# UNITED STATES PATENT AND TRADEMARK OFFICE

APPLICATION NO.	FILING DATE	FIRST NAMED INVENTOR	ATTORNEY DOCKET NO.	CONFIRMATION NO.
10/595,441	04/19/2006	Pierre Beteille	171.004	9671
38245 7590 09/28/2007 JEROME D. JACKSON (JACKSON PATENT LAW OFFICE) 211 N. UNION STREET, SUITE 100 ALEXANDRIA, VA 22314			EXAMINER CADUGAN, ERICA E	
			ART UNIT 3722	PAPER NUMBER
			MAIL DATE 09/28/2007	DELIVERY MODE PAPER

<b>Office Action Summary</b>	<b>Application No.</b> 10/595,441	<b>Applicant(s)</b> BETEILLE, PIERRE	
	<b>Examiner</b> Erica E. Cadugan	<b>Art Unit</b> 3722

## **DETAILED ACTION**

Example of a portion of the table 3  
that can be considered a  
“rigidification beam”

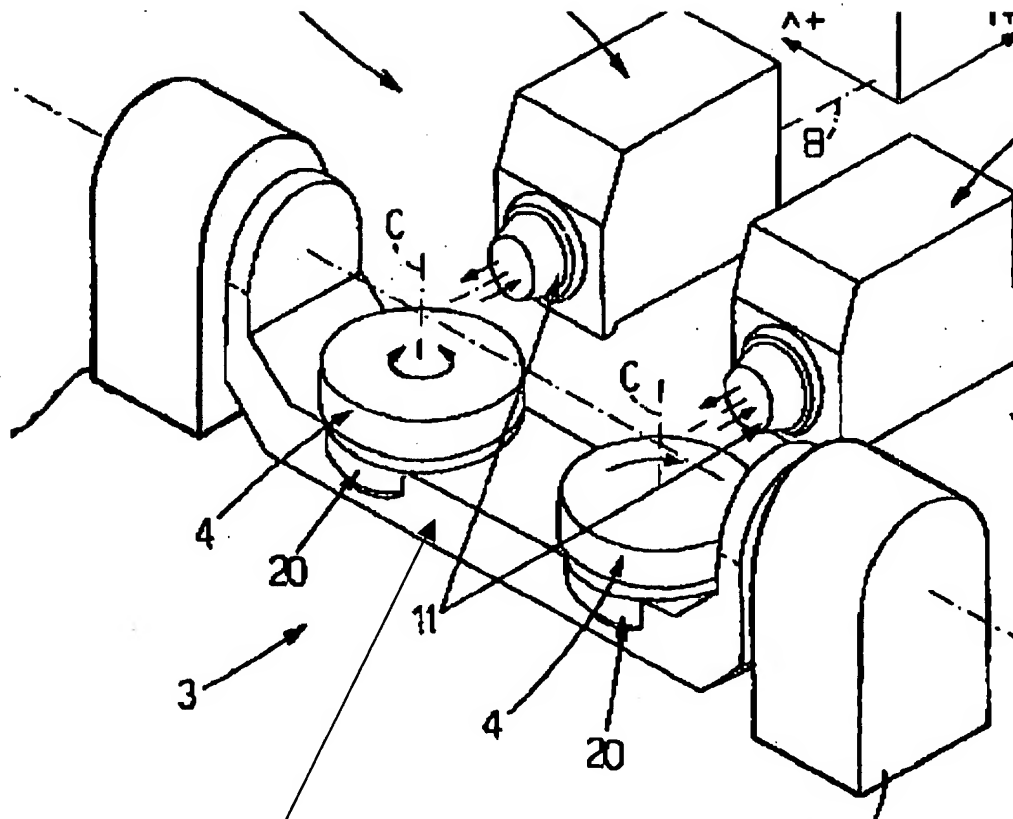
Re claim 3, see the partial reproduction of Figure 4 labeled below, and also note that platforms 4 can be considered “receiving plates” as broadly claimed.

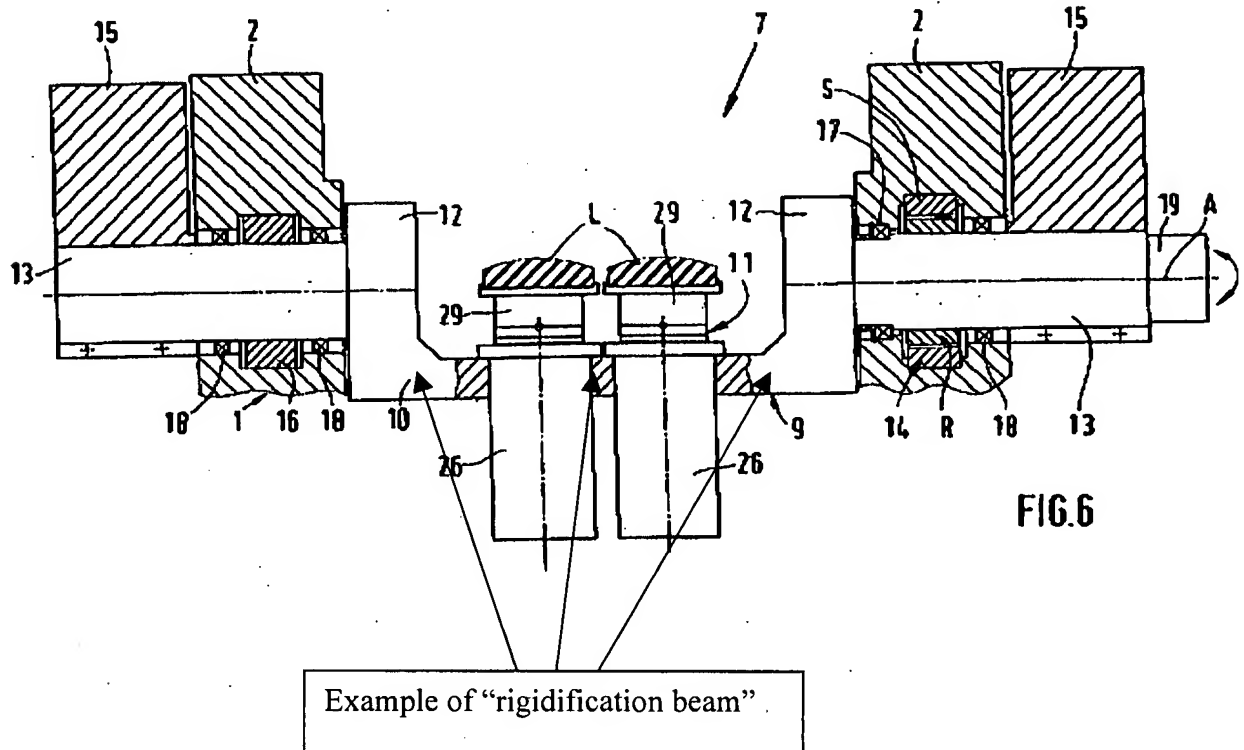
Re claim 3, see the reproduction of Figure 6 below, noting that the upper portion of element 29 can be considered a “receiving plate”, for example.
